# Access Compliance Report

## Public Rights-of-Way

### (Curb Ramps)

Intersection ID: 15051	Main Street: FILLMORE_AV	Cross Street: KENILWORTH_AV	Location: E
ADA ID: F3C9A3B46EAE	Ramp Type: Directional1	Initial Pass/Fail: Fail	Overall Compliance: No
Severity Score: 12.5			
Codes/Mitigation Info/Possible Solution		Field Measurements/Component Compliance

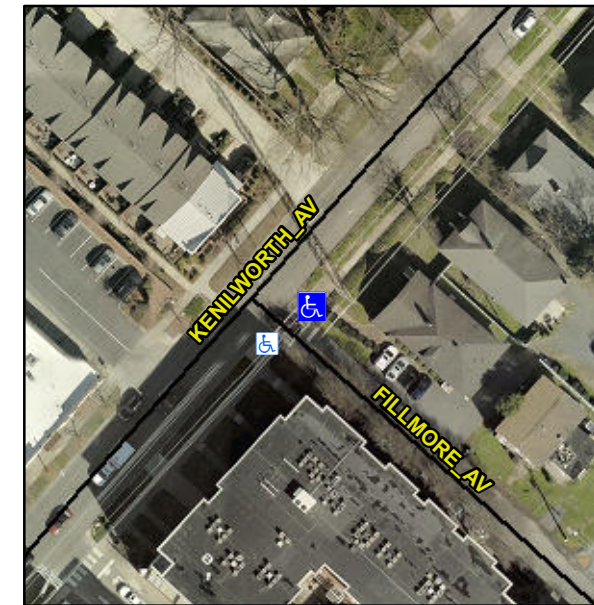
**Remove & Replace Entire Ramp.**

**R304.5.3**

Compliance	Description	Data	Compliance	Description	Data
N/A	Ramp Length (in)	58.0	N/A	Grade Break?	N/A
Yes	Ramp Width (in)	60.0	N/A	Grade Break Slope (%)	0.0
Yes	Ramp Slope (%)	2.2	N/A	Grade Break XSlope (%)	0.0
No	Ramp XSlope (%)	5.6			
N/A	Flare Type LT	N/A	N/A	Flare Type RT	N/A
N/A	Flare Slope LT (%)	N/A	N/A	Flare Slope RT (%)	0.0
N/A	Flare Traversable LT?	N/A	N/A	Flare Traversable RT?	N/A
N/A	Landing Length (in)	0.0	N/A	DWS Provided?	N/A
N/A	Landing Width (in)	0.0	N/A	DWS Contrast?	N/A
N/A	Landing Slope (%)	0.0	N/A	DWS Length (in)	N/A
N/A	Landing X Slope (%)	0.0	N/A	DWS Full Width?	N/A
N/A	Landing Curb? (Y/N)	N/A	N/A	DWS Offset LT (in)	N/A
N/A	Shared Landing?	N/A	N/A	DWS Offset RT (in)	N/A
N/A	Gutter Ponding?	Yes	N/A	Gutter Slope (%)	N/A
N/A	Gutter Lip Ht (in)	0.0	N/A	Gutter X Slope (%)	N/A
N/A	Painted X Walk1?	Yes		Road Slope (%)	7.9
	X Walk 1 Direction	To SW		Road X Slope (%)	3.2
	X Walk 1 Width (in)	113.0		Clear Space?	N/A
